1865 Woodmoor Drive - As Built
Existing Retaining Wall Heights

Sunshine Behavioral Health
1865 Woodmoor Drive
Monument, CO 80132

As-Built Exg
Retaining Wall Plan

SD1.0

As Built Existing Retaining Wall Site Plan
Scale: 1/16" = 1'-0"

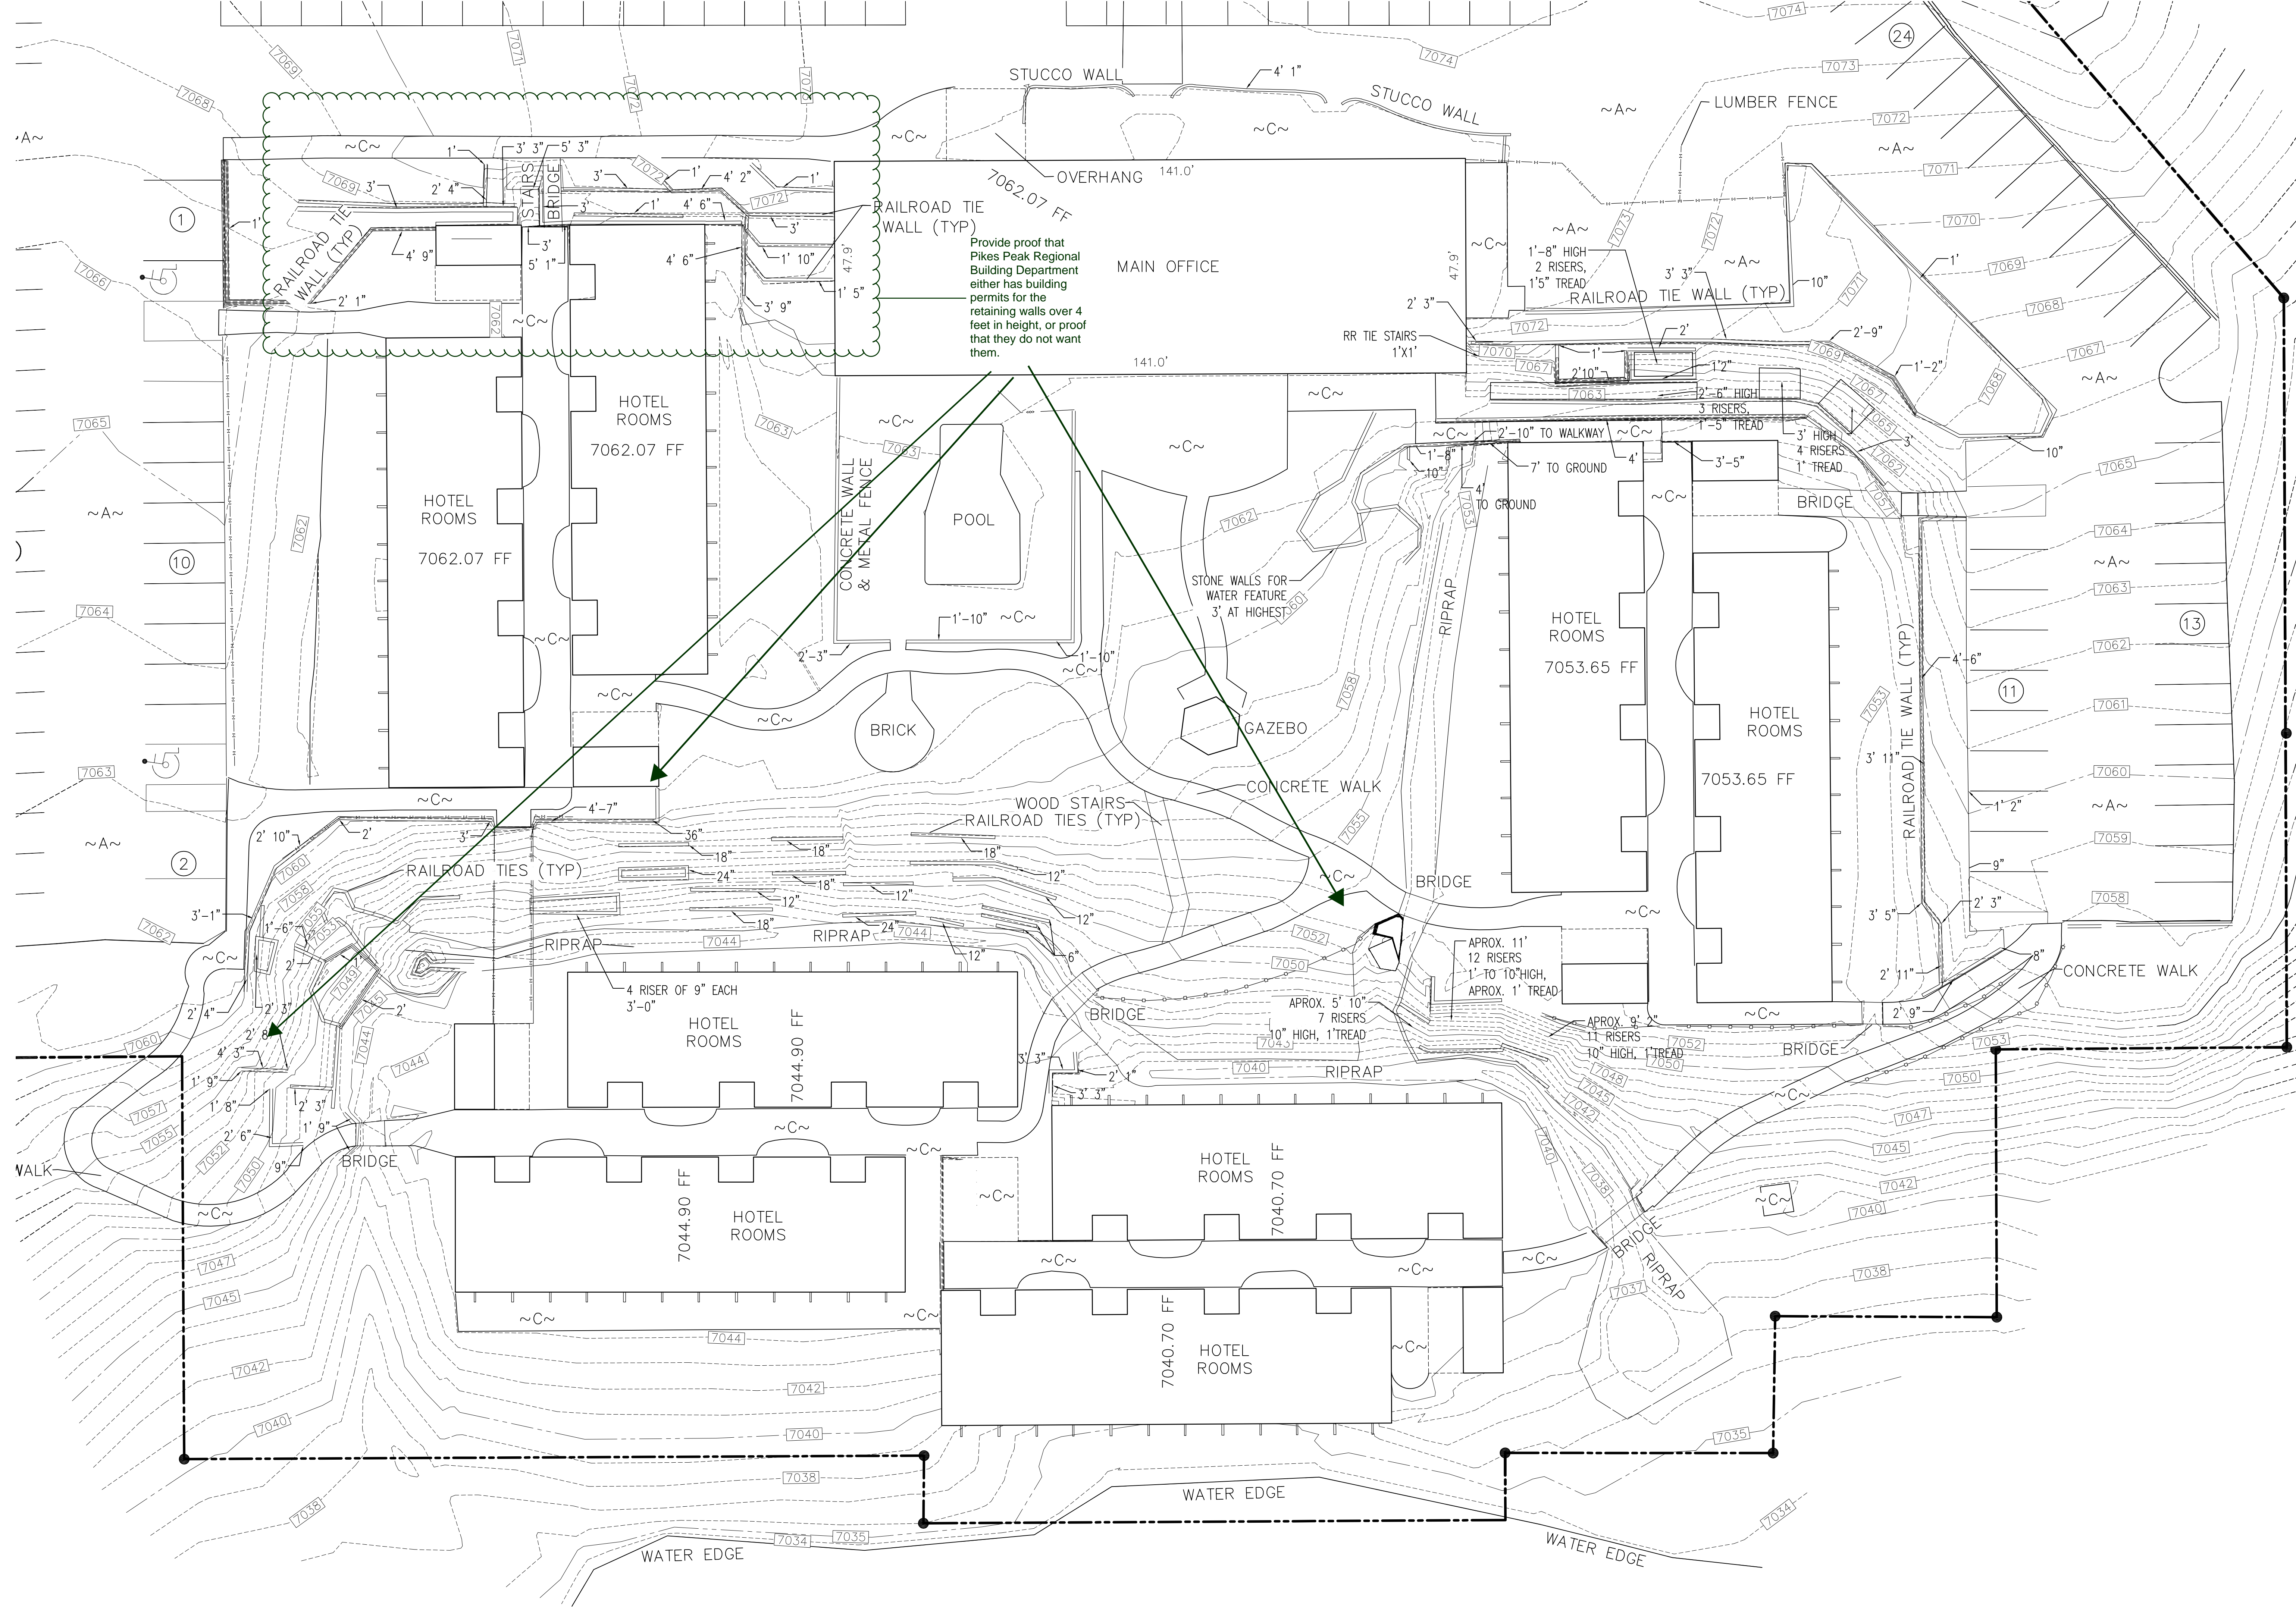
Provide proof that Pikes Peak Regional Building Department either has building permits for the retaining walls over 4 feet in height, or proof that they do not want them.
